# Access Compliance Report Public Rights-of-Way (Curb Ramps)

Main Street: SWIDLER\_PL Cross Street: LARKSTONE\_DR Location: NE

ADA ID: RPAT211005123135 Ramp Type: Type 1 - Perpendicular Diagonal Initial Pass/Fail: Pass Overall Compliance: No Severity Score: 22

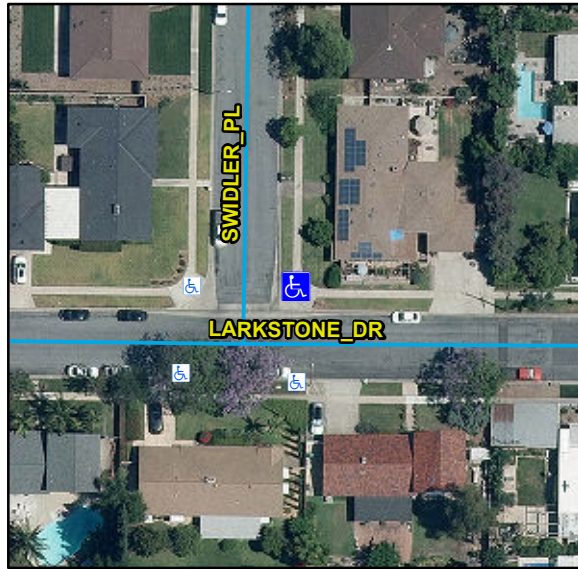
R304.2.2, R204.3, R304.2.1, R304.2.2-Perp, R304.3.2-Para, R304.5.3, R305, STD 1115

| Compliance | Description                           | Data | Compliance | Description                   | Data   |
|------------|---------------------------------------|------|------------|-------------------------------|--------|
| No         | Landing Width (in)                    | N/A  | N/A        | Flare Slope RT (%)            | 10     |
| No         | Landing Run Slope (%)                 | N/A  | N/A        | Flare Traversable RT          | No     |
| No         | Landing Cross Slope (%)               | N/A  | No         | DWS Provided                  | No     |

Remove & Replace Curb Ramp With Two New Directional Ramps or Equivalent.
